Executive Director's Recommendation

Commission Meeting: July 7, 2016

PROJECT New Perimeter Fence and Gates White House Complex 1600 Pennsylvania Avenue, NW Washington, DC	NCPC FILE NUMBER 7776
SUBMITTED BY United States Department of the Interior National Park Service	NCPC MAP FILE NUMBER 1.31(38.40)44366
REVIEW AUTHORITY Federal Projects in the District per 40 U.S.C. § 8722(b)(1) and (d)	APPLICANT'S REQUEST Approval of comments on concept design
	PROPOSED ACTION Approve comments as requested
	ACTION ITEM TYPE Staff Presentation

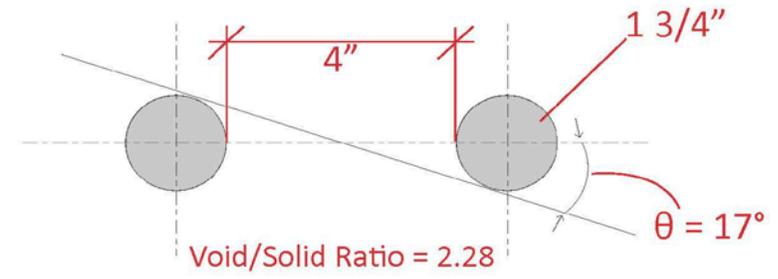
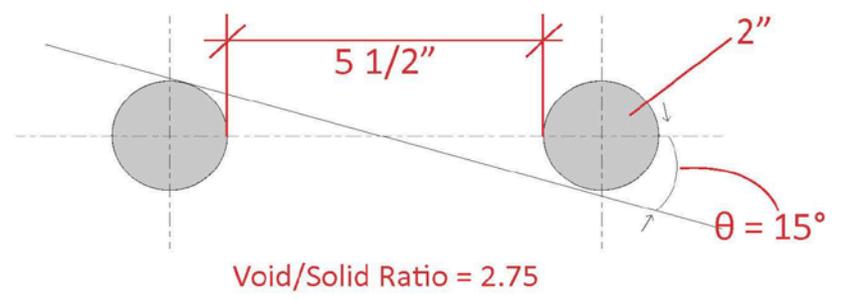
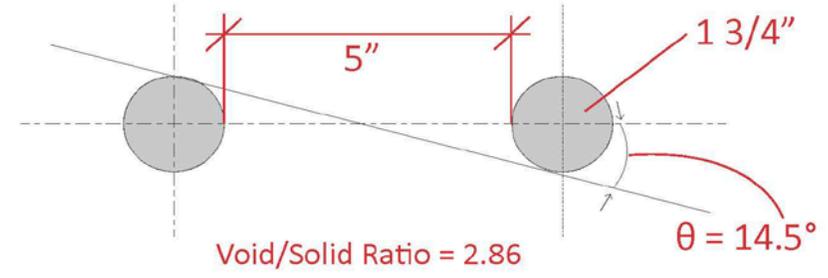
Notes two alternatives for picket size and spacing have been submitted, including a 2" picket with 5-1/2" spacing, and a 1-3/4" picket with 5" spacing.

Comments favorably on the 2" picket with 5-1/2" spacing as the NPS and USSS preferred alternative, noting that the wider picket spacing may provide better visual access to the White House and grounds for visitors located near the fence.

Option 1A

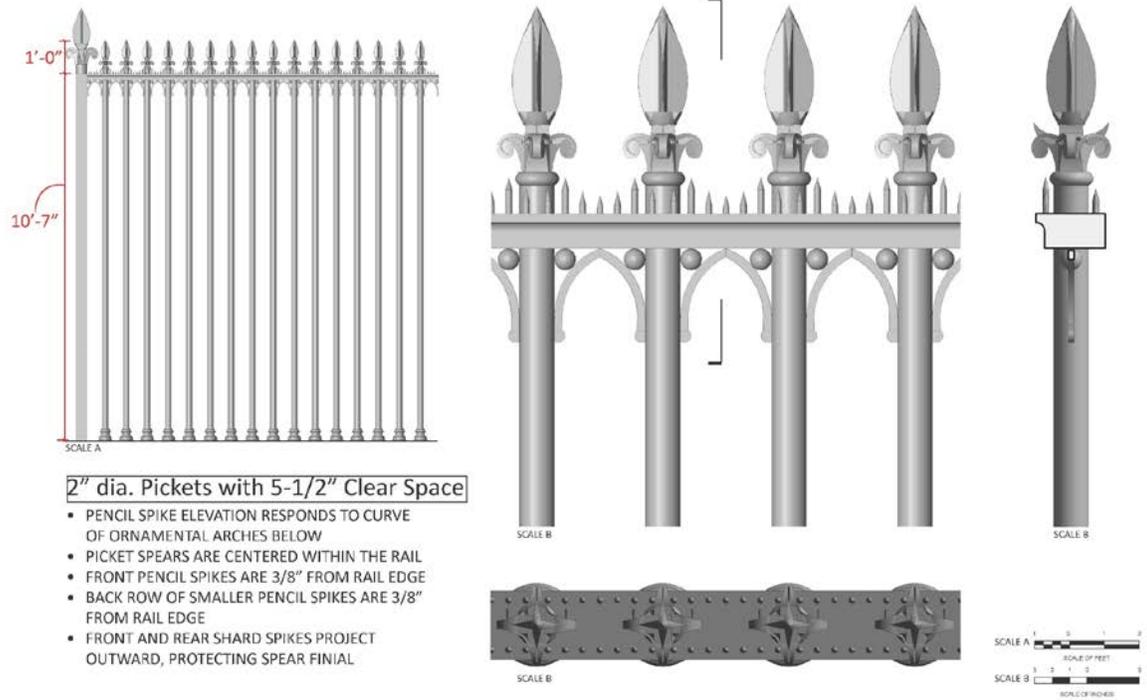
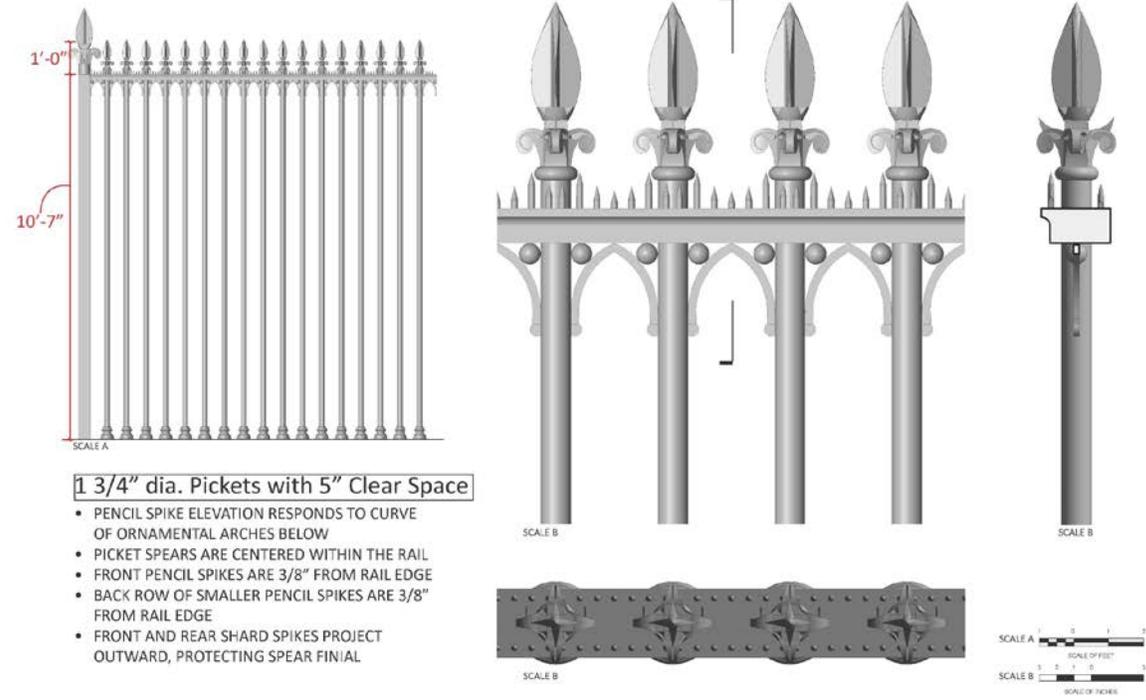
Comments that Option (1) appears somewhat ornate and may visually compete with the more modest neo-classical style of the President's residence.

Option 2A

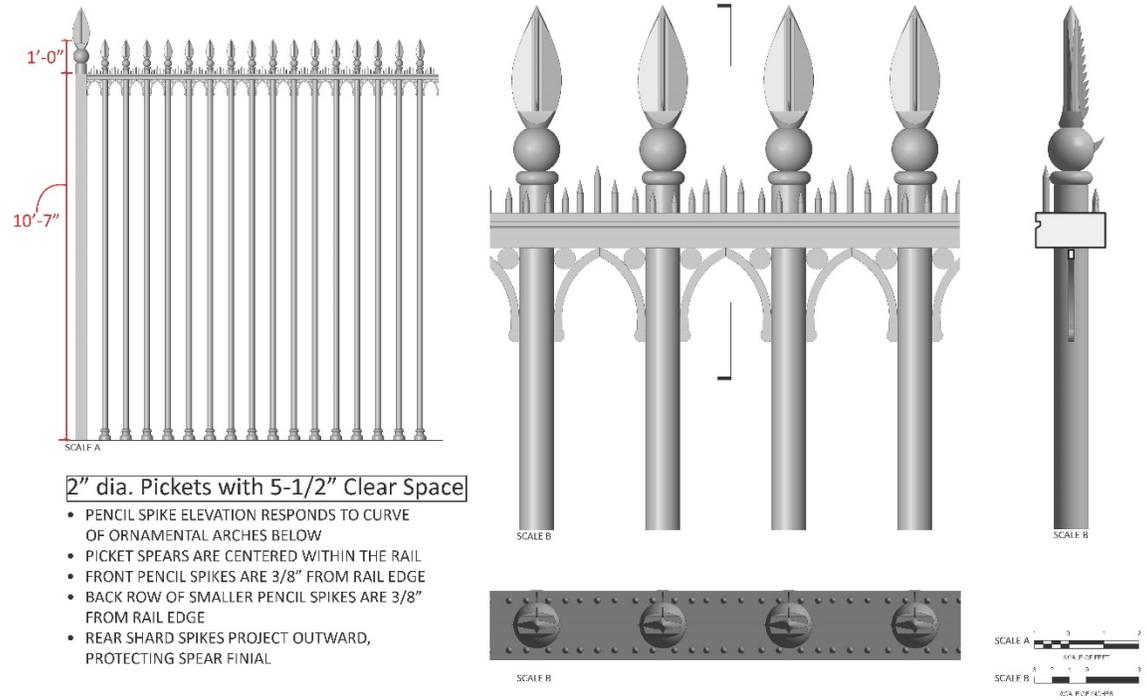
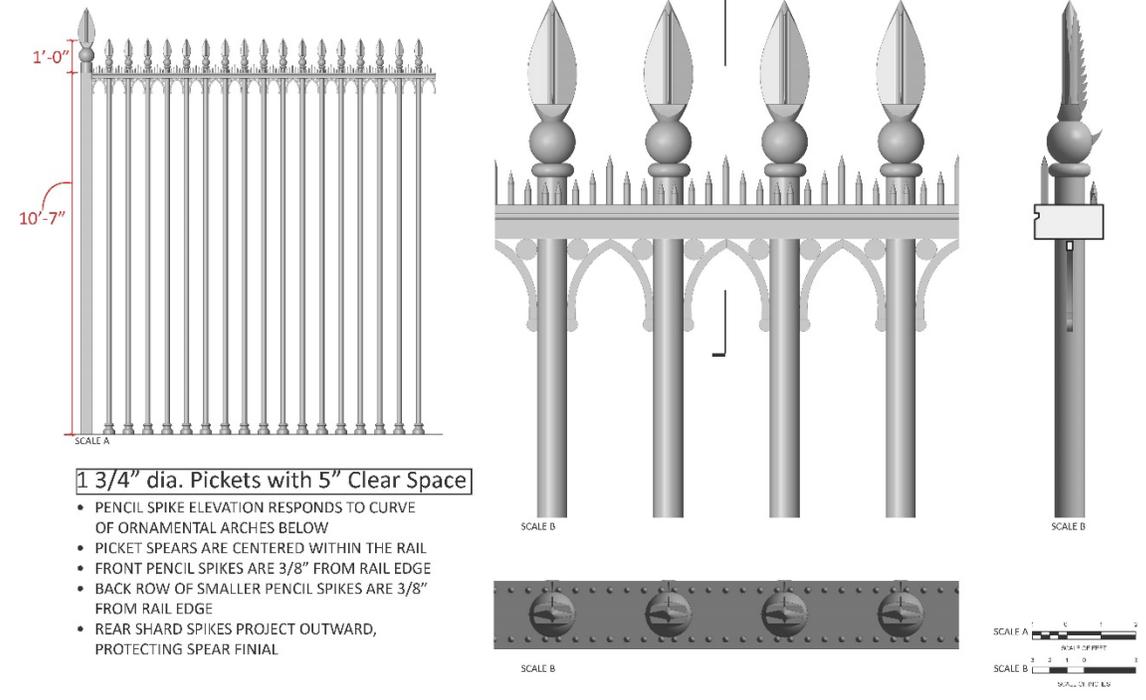
Comments favorably on the fence design for Option (2), as it provides an appropriate hierarchy of ornamental and security elements, and limits the visual weight of the fence top.

Option 3A

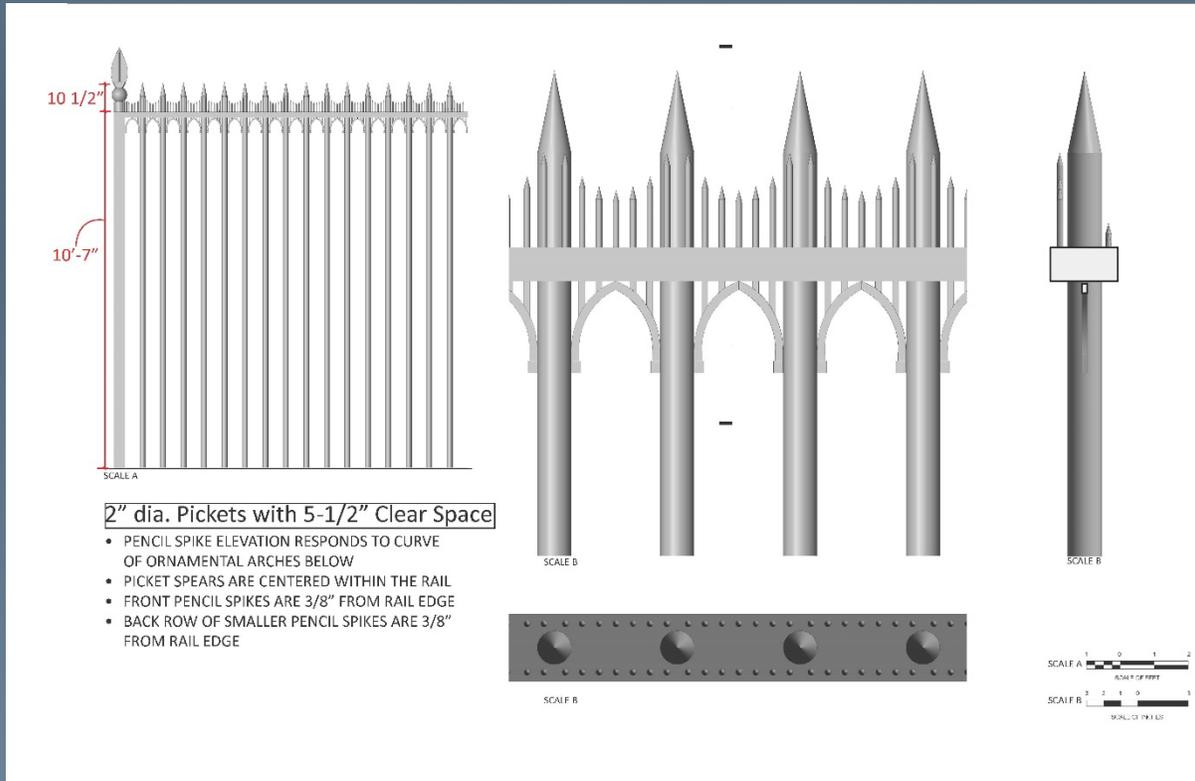
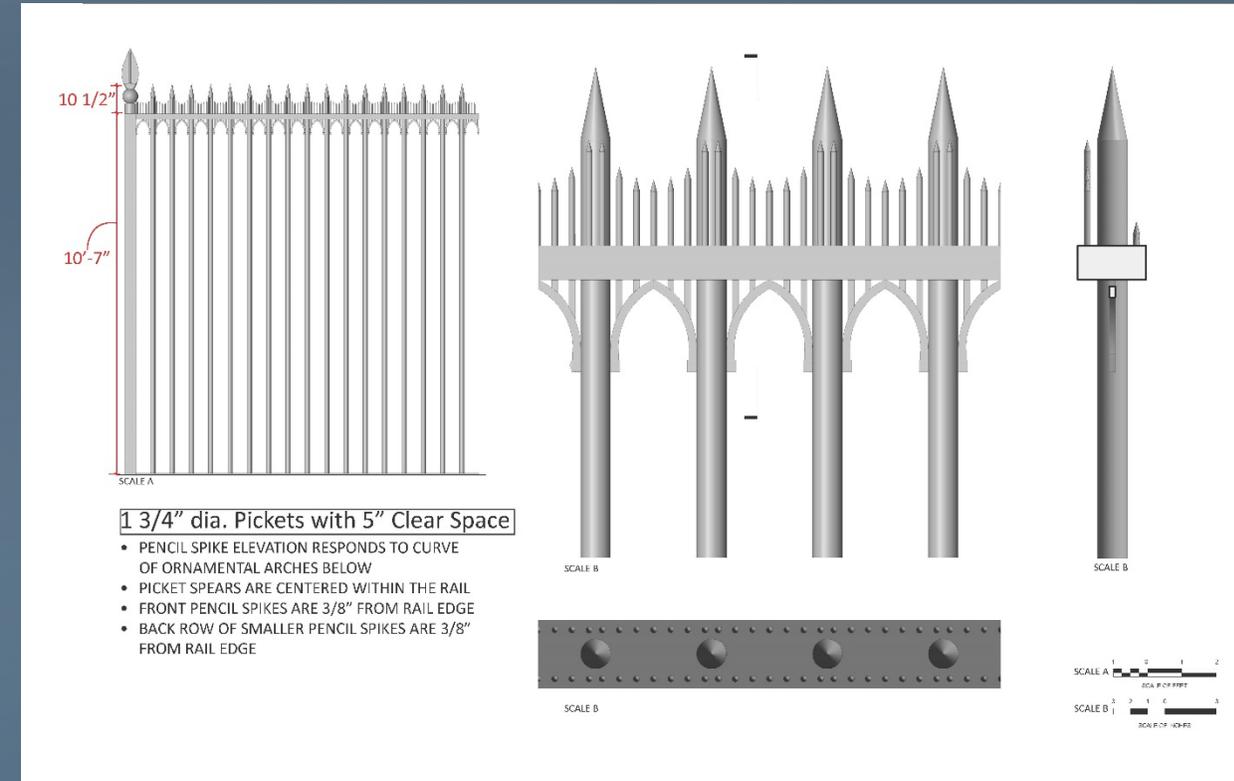
Does not support Option (3) as it emphasizes security elements instead of ornamental features, and will therefore detract from the visitor experience.
